# TECHNICAL NOTE

| Project     | Site A Willow Way, Sydenham                  |                           | Project No. | 22/089  |             |
| Subject     | Technical Note in Support of Planning Appeal |                           | Document No | TN004   |             |

**Table 1-1: LBL Officer Report Comments on the Application and VTP Response**

Drawing file: 4770-2001-T-004-005-A - Swept Path Analysis - Car.dwg Date: May 11, 2023 - 10:44am

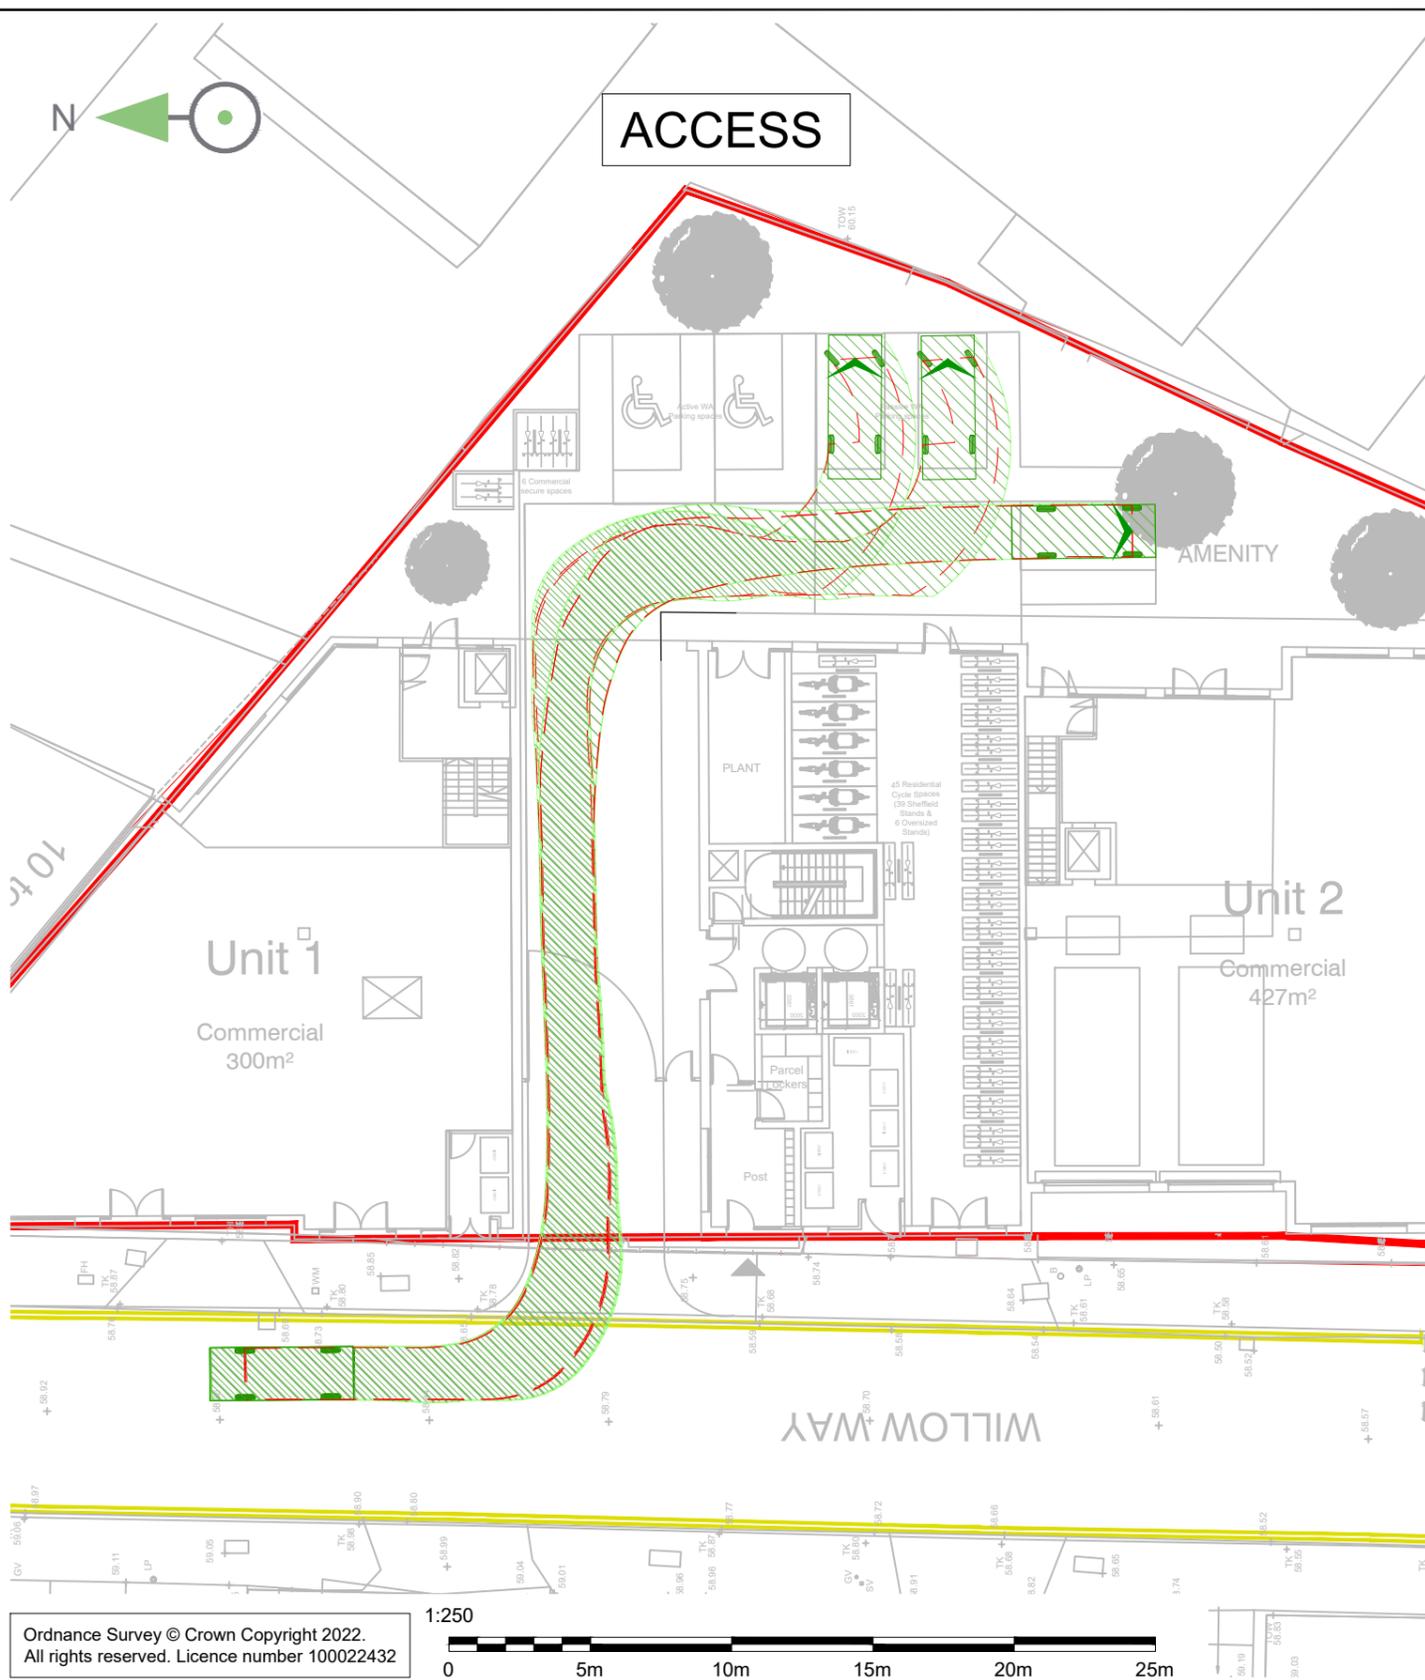
| PARAGRAPH | PLANNING OFFICER / LBL HIGHWAYS COMMENT   | VTP RESPONSE   |
|-----------|---|--|
| 324       | <p><b>Disabled Parking Spaces:</b><br/>The application omits one disabled parking space associated with the commercial proposals for staff or visitors. Policy T6.5 non-residential disabled parking stipulates access to at least one disabled parking bay (on or off street). This will need to be addressed.</p> <p>The application should also be accompanied with swept paths of a large vehicle accessing parking and egressing the site which has not been provided.</p> | <p>It is accepted that a specific disabled parking space for the commercial element has been omitted as part of the application. Given the proposals include safeguarded space on-site to accommodate an extra 3 disabled parking spaces, it is considered that one of these spaces could be allocated to the commercial element in the first instance.</p> <p>An additional on-street space could be provided (within the public highway, and therefore outside of the application boundary) in order to maintain the safeguarded provision for 10% of the residential units to have a disabled parking space. This could be provided as part of the TRO process, should it be required.</p> <p>As the number of blue badge holders within Lewisham's population is around 2% (DfT Statistics, Table DIS0109, 2016 data), it is considered highly unlikely that there will be demand by residents for use of all six disabled bays proposed in the application. Blue badge holders in Lewisham can also park on single or double yellow lines for up to three hours where loading/unloading is permitted (Section 4.3 of LBL Parking Policy, March 2023) meaning any demand by visitors can reasonably be accommodated on-street.</p> |

| PARAGRAPH | PLANNING OFFICER / LBL HIGHWAYS COMMENT   | VTP RESPONSE  |
|-----------|---|---|
|           |   | <p>The revised approach is therefore considered to be acceptable within the constraints of the site.</p> <p>It is anticipated that access to the rear parking court will only be permitted to standard sized service vehicles in exceptional circumstances such as plant needing maintenance. The rear parking court was therefore designed primarily to accommodate movements of cars.</p> <p>Swept path analysis shown in <b>APPENDIX F</b> demonstrates that large cars can access and egress all parking spaces adequately.</p> |
